MIL-C-60104A(MU)
AMENDMENT 3
7 October 1968
SUPERSEDING
AMENDMENT 2
24 May 1968

MILITARY SPECIFICATION

CONTAINERS, SHIPPING, REUSABLE: 8246020 AND 10539215

This amendment forms a part of Military Specification MIL-C-60104A(MU), dated 10 August 1967.

FIG. 1-CONTAINER ASSEMBLY

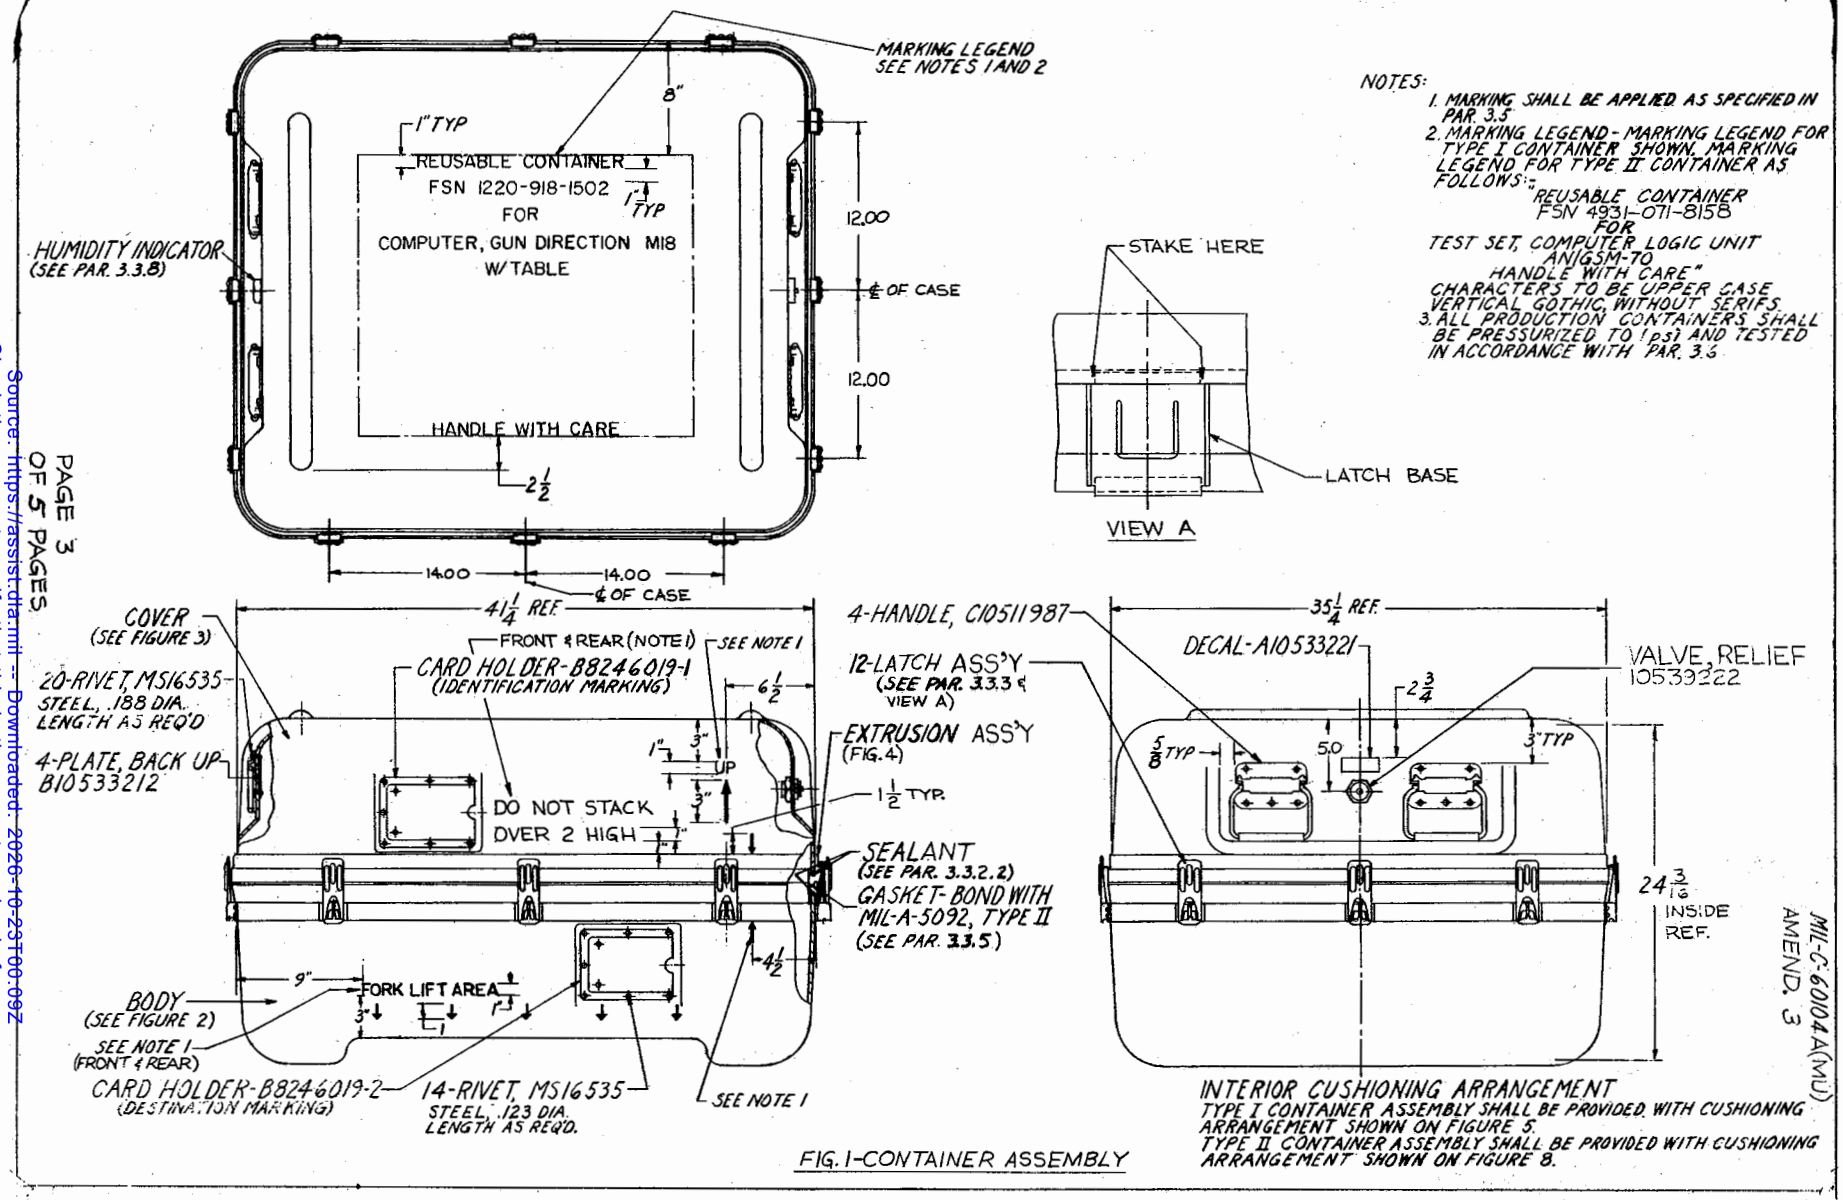
"3.3.3 Latches.- Twelve (12) latches conforming to Drawing C10556000 shall be located and secured to lower sealing extrusion as shown on Figure 1. The latch incorporates a spring detent in the base plate which engages into provided offset in sealing extrusion when the latch is positioned into the extrusion rail. Stake the extrusion rail in two (2) places to prevent lateral movement of latch base plate. Each latch shall be properly adjusted and cotter pinned to assure uniform pressure on sealing gasket. Touch-up paint shall be applied to stake marks with paint conforming to TT-E-529, Color X24087 of FED-STD-595.

"3.5 Marking.- Marking legends shown on Figure 1 shall be applied by silk screen or stencil with paint conforming to TT-E-529, Color White 27875 of FED-STD-595."

Delete: "Figure 1" and substitute attached "Figure 1".

FIG. 3-COVER

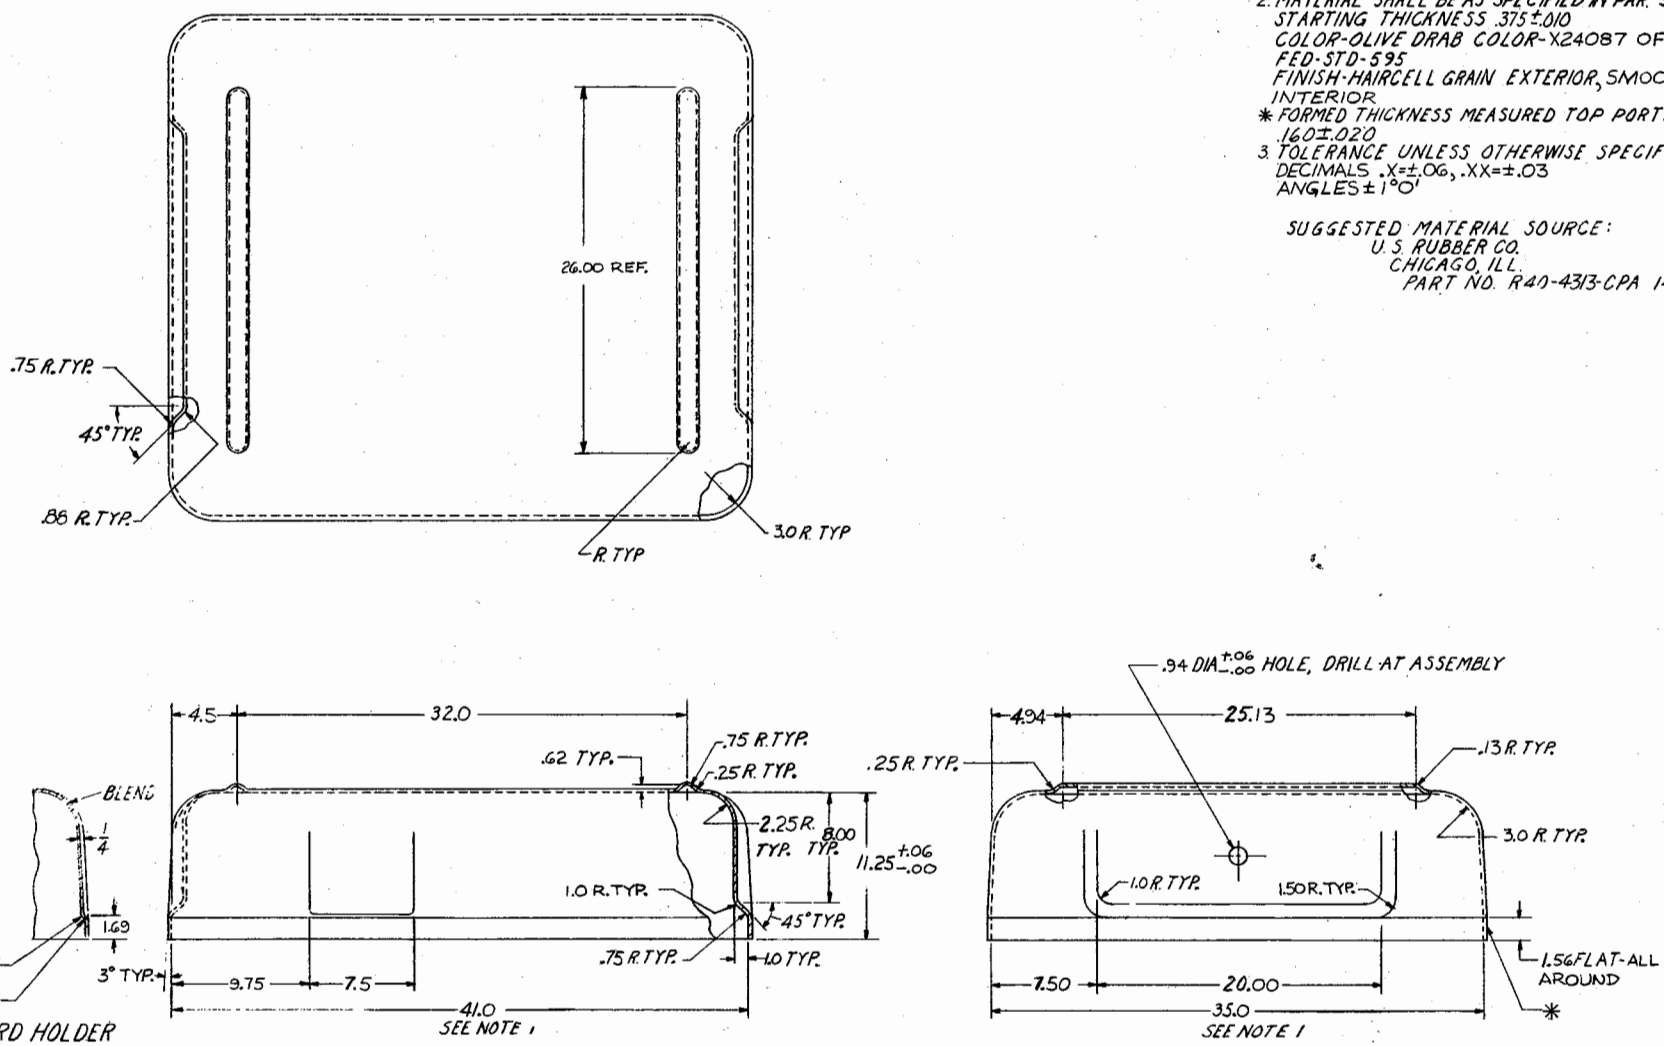
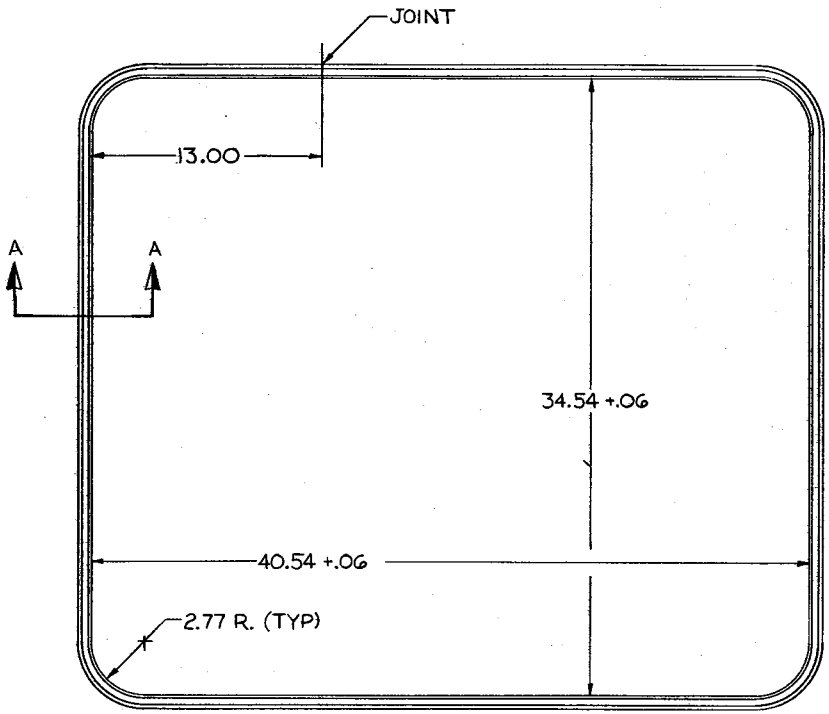
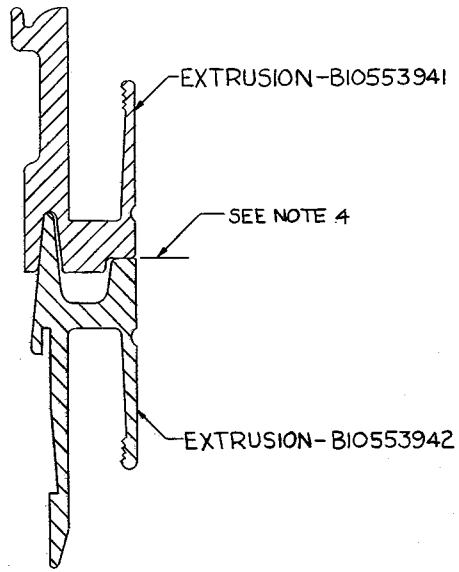
Delete: "Figure 3" and substitute attached "Figure 3".
